DCN 1430-3

ANNUNCIATOR CABINET A

DCP PACKAGE INDEX
 ITEM NO. 6.2.24

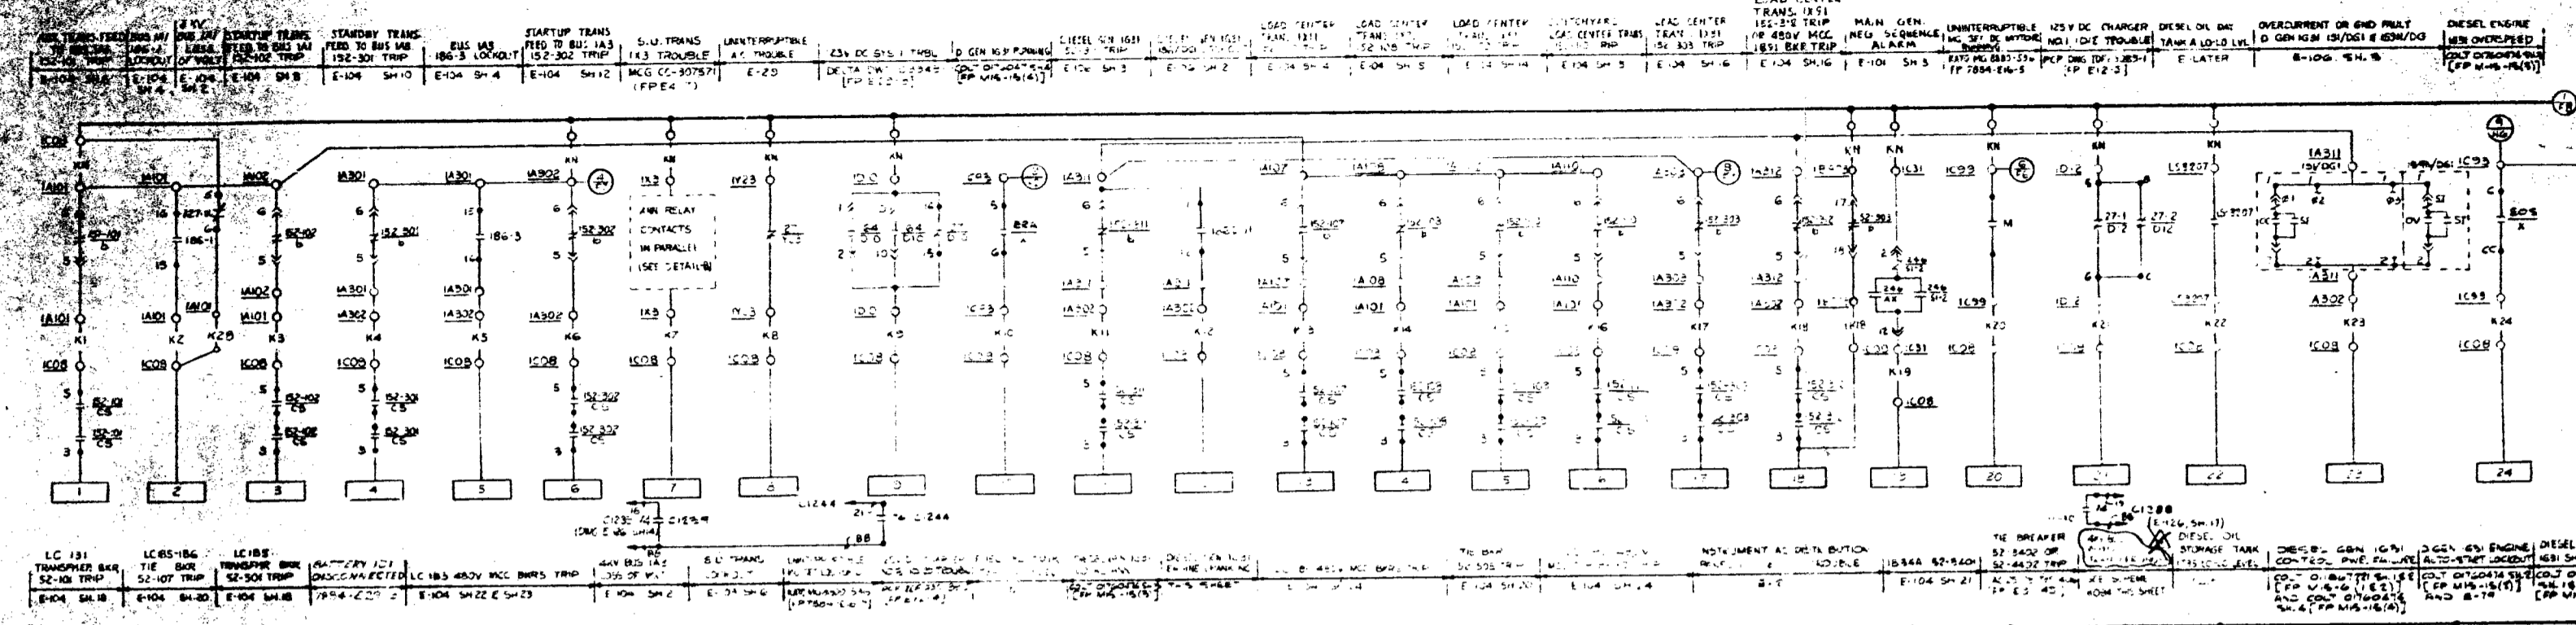
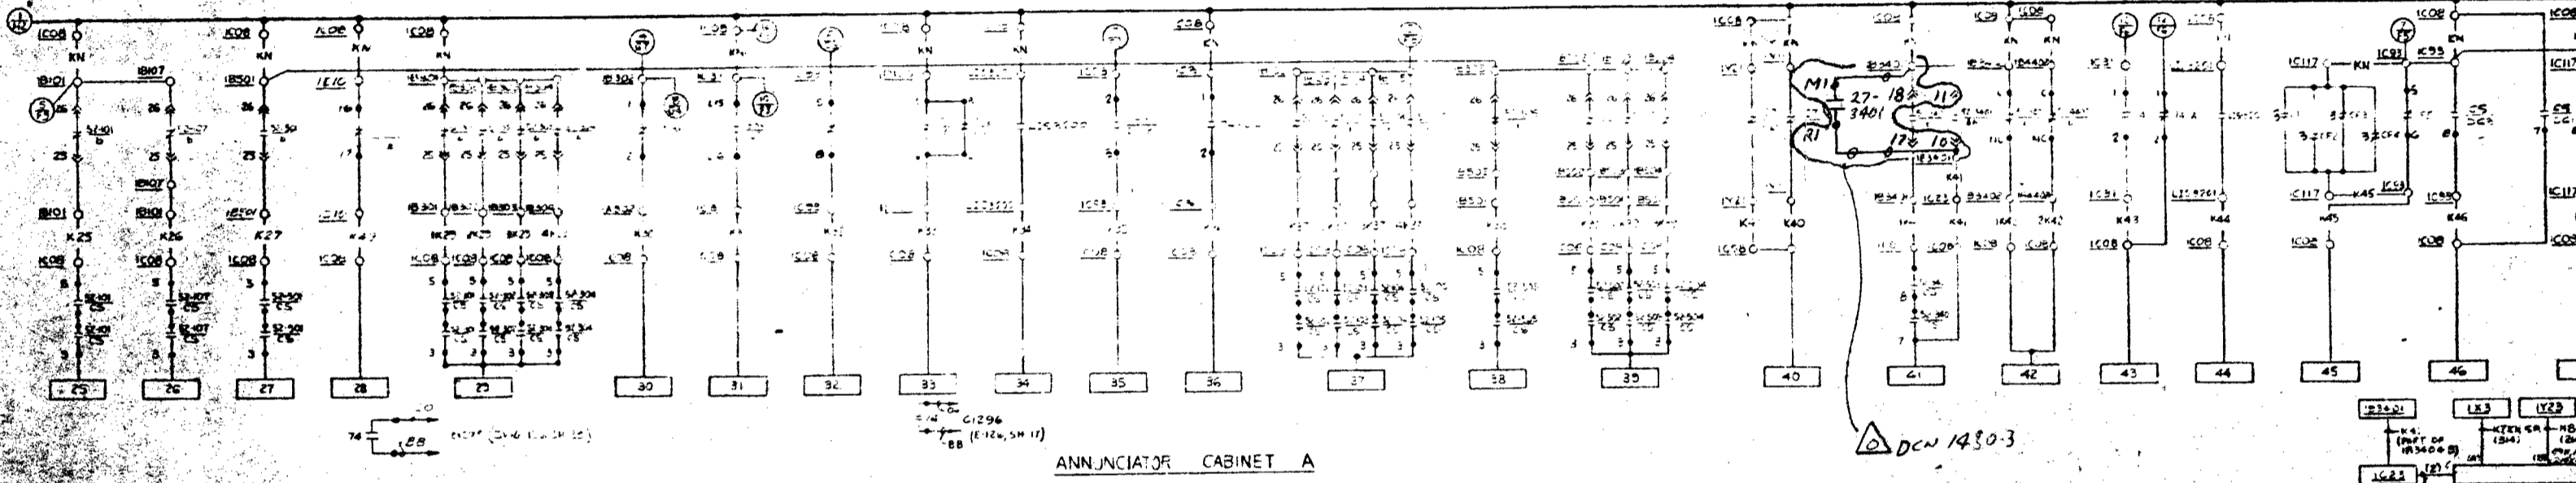
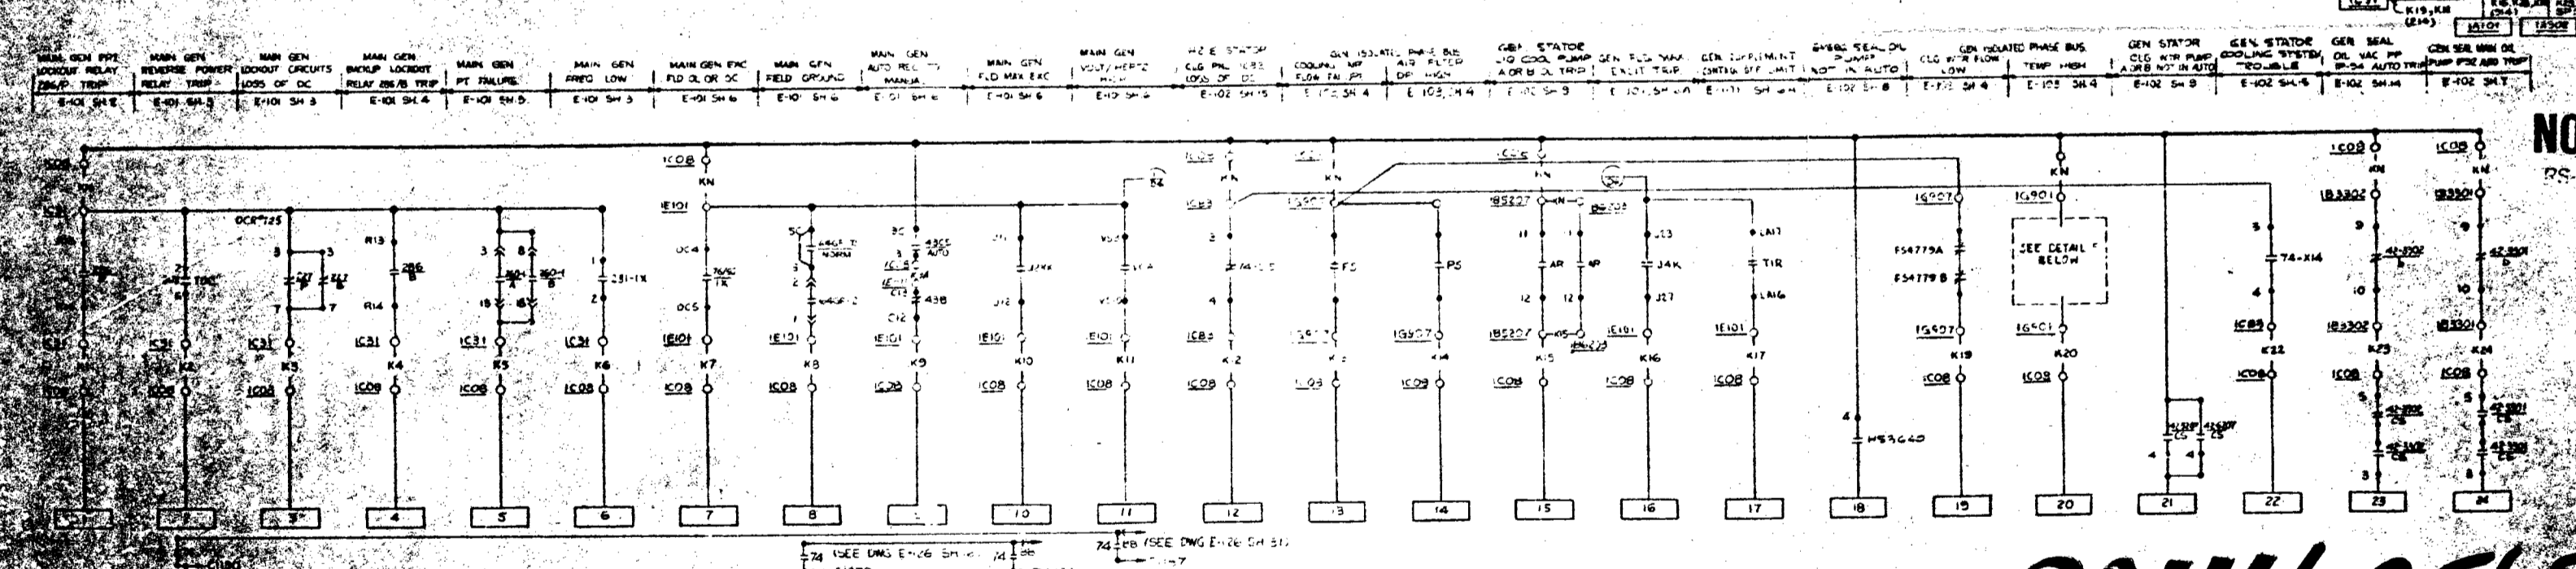
DCN 1430-3
